# HISTORIC DISTRICT COMMISSION ADDITIONAL INFORMATION REQUEST

**Application Number:** HDC2025-00464

**PROJECT ADDRESS:** 2025 Orleans Street

**HISTORIC DISTRICT:** Lafayette Park/Mies van der Rohe

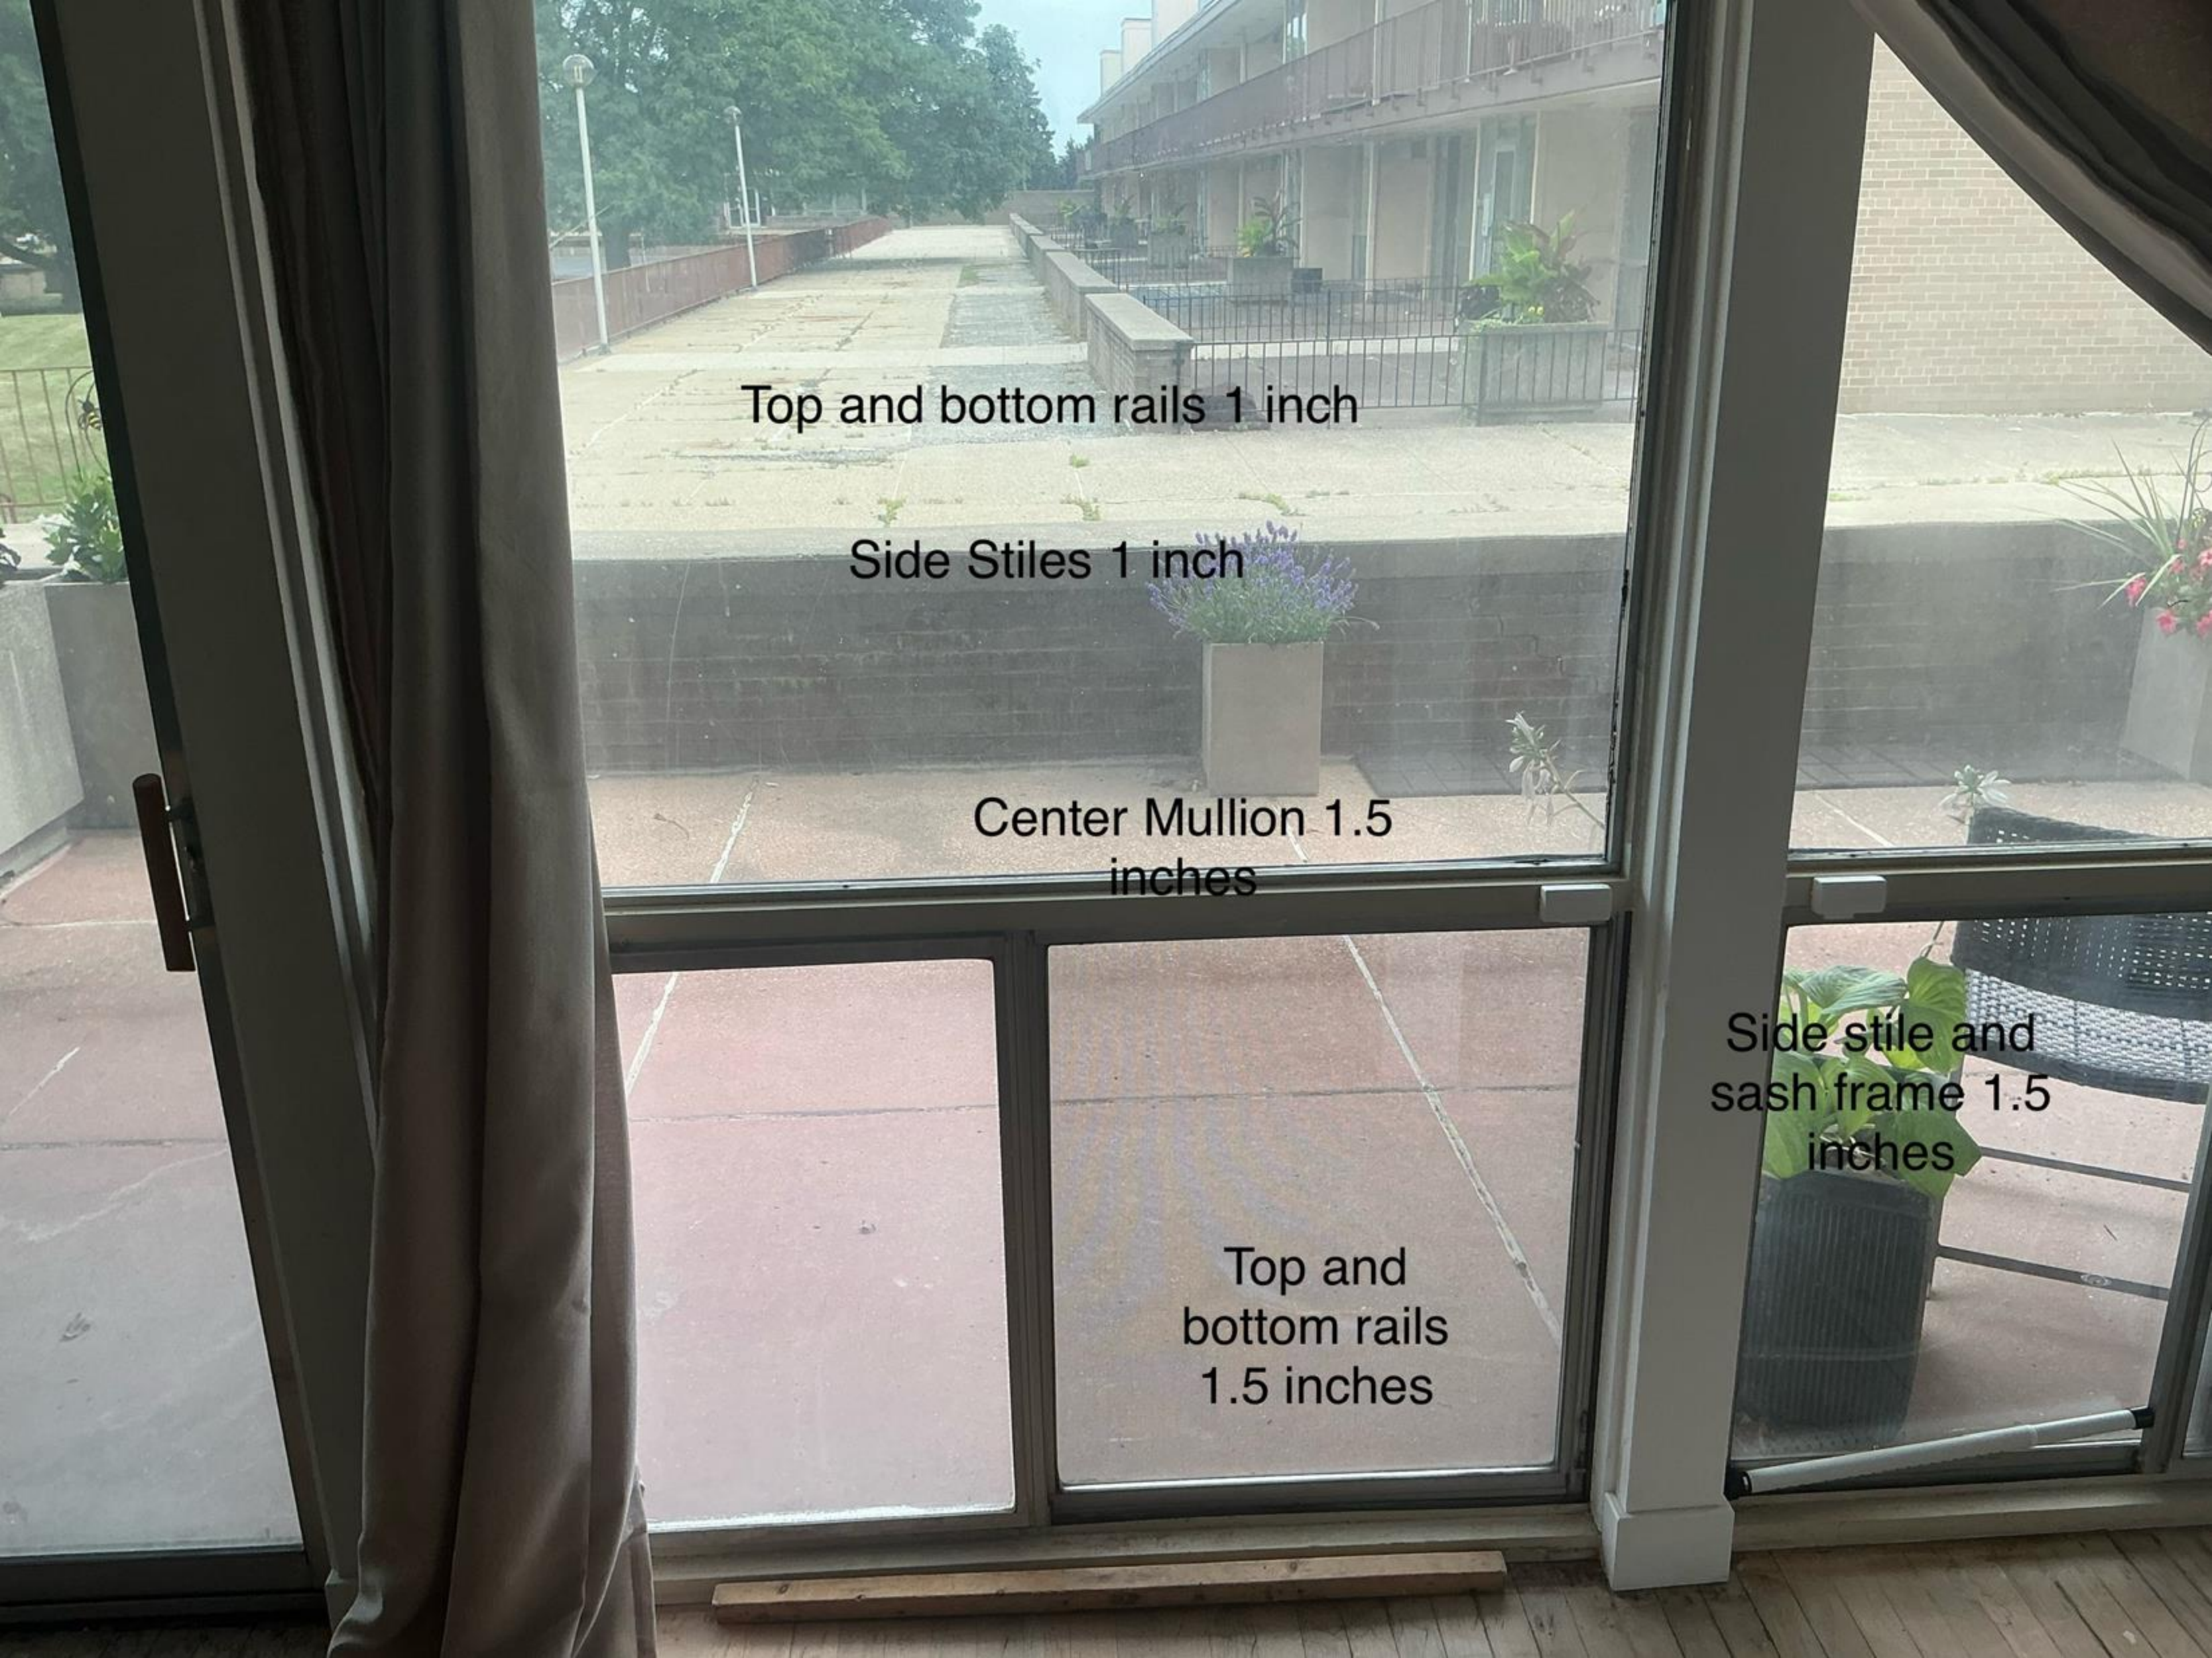
This application is not yet complete. We need to understand the replacement windows in relation to the existing windows to determine if they will be appropriate replacements. As you have provided detailed dimension drawings for the proposed windows, please provide the same details for the existing (jams, sills, muntins, headers, etc)

See attached

Top and bottom rails 1 inch

Side Stiles 1 inch

Center Mullion 1.5  
inches

Side stile and  
sash frame 1.5  
inches

Top and  
bottom rails  
1.5 inches

Top Rail 1.5 inches

Side Stile 1.5  
inches

Side Stile 1.5  
inches

Threshold 1.5  
inches

Bottom Rail 2  
inches
